INSPECTION AND REPLACEMENT OF NOSE GEAR DRAG LINKS

Lancair IV, IV-P, IV-PT, and Legacy

SERVICE BULLETIN SB077-0518

Figure 3

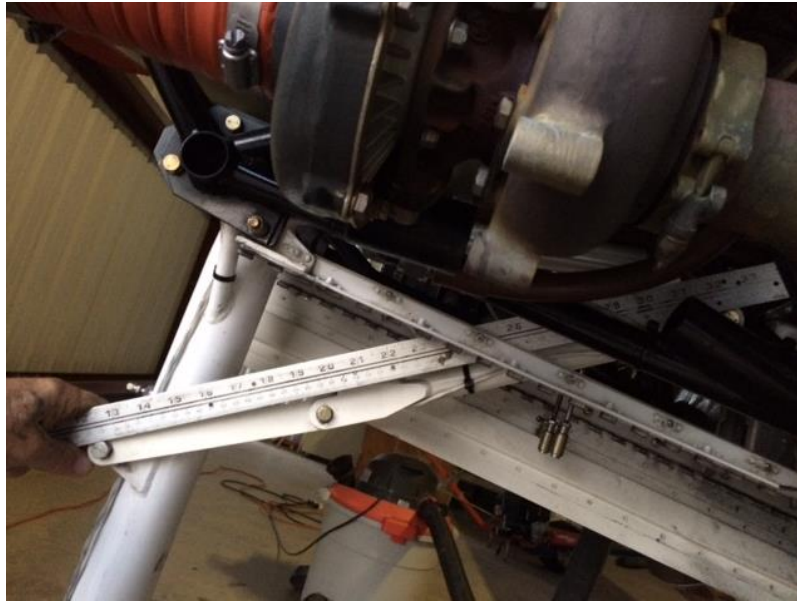
- 6.2.1** Aircraft equipped with the original steel-on-steel pivots (without the bronze bushings) will have a bolt with a castle nut and it is secured with a cotter pin.
- 6.2.1.1** Using a straightedge, check that the drag links are over-center shown in Figure 3. There is no "over-center distance" specified, but a range from $\frac{1}{4}$ " to $\frac{1}{2}$ " as measured from the centerline of the pivot bolt joining the upper and lower links is ideal.

- 6.2.1.3** With the gas spring disconnected and the nose wheel off the ground, apply fore/aft force to the nose wheel, and observe any movement of the pivot point between the upper and lower drag links. Any amount of wear in the pivot joints between the drag links will cause the joint to move when fore/aft pressure is applied to the nose wheel because the steel-on-steel contact point between the ears of the lower drag links and the upper link acts as the initial pivot point for the assembly. If wear in the joint is sufficient to allow it to move over-center as measured in step 6.2.1.1 above, the nose gear is restrained from retracting at touchdown only by the combined hydraulic and gas spring pressure. If either fails, the nose gear could retract upon a normal touchdown.

- 6.2.1.4** If the above test indicates the drag link pivot point moves past, or close, to the over-center position, replacement of the drag link assembly is dictated. Once this joint develops free play, the wear rate will increase exponentially until it fails.

- 6.2.1.5** In most cases, replacement of the two lower drag links with the improved design lower drag links and the correct installation of the new hardware between the upper and lower links will correct this problem. If the holes in the upper overcenter link have been worn excessively, replacement of this part is also indicated.

Figure 4

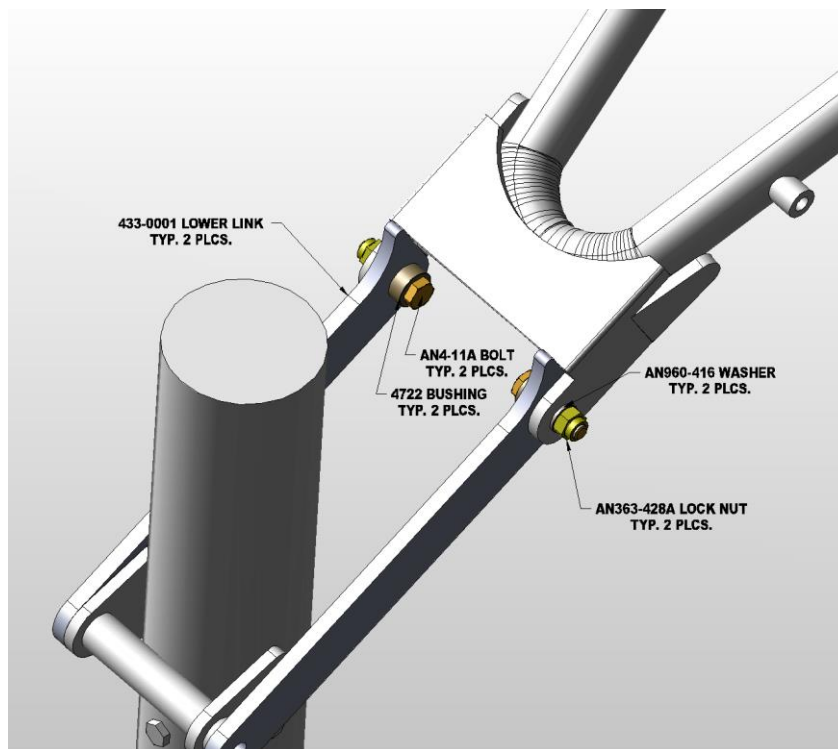
- 7.1** The original upper and lower nose gear drag links were joined with a drilled bolt and castellated nut that permitted the links to pivot on the bolt. The improved lower drag links being provided REQUIRE the two drilled bolts/castellated nuts that served as the center drag link pivot be replaced with tension bolts and locking nuts. This serves to make the two lower drag struts pivot on the new bushings provided, rather than on the attachment bolts. We strongly recommend you not re-use the original bolts because they are likely worn and may not provide the needed security for the bronze bushings being clamped to the upper drag link.

- 7.2.1** Lubricate lightly and install each 4722 Bronze Bushing in one of the new 433-0001 Lower Drag Links.
- 7.2.2** Ensure the small diameter of the 4722 Bushing protrudes a minimum of 0.035" beyond the flat face of the lower drag link.

- 7.2.3** With the large diameter of the 4722 Bushing on the inside face of the 433-0001 Lower Drag Link, install the new lower links to the overcenter link using NEW AN4-11A Bolts (head on inside face of 4722 Bushing), AN960-416 Washers and AN363-428A Steel Lock Nuts.

- 7.2.4** Before attaching the 4722 Lower Drag Links to the nose strut, torque the above bolts to 90-100 in./lb and ensure each of the two lower links will pivot on the upper link through the full range of movement required during gear retraction. Do not continue re-assembly until this condition is satisfied for both lower links. This may require removal of paint from the mating surfaces.
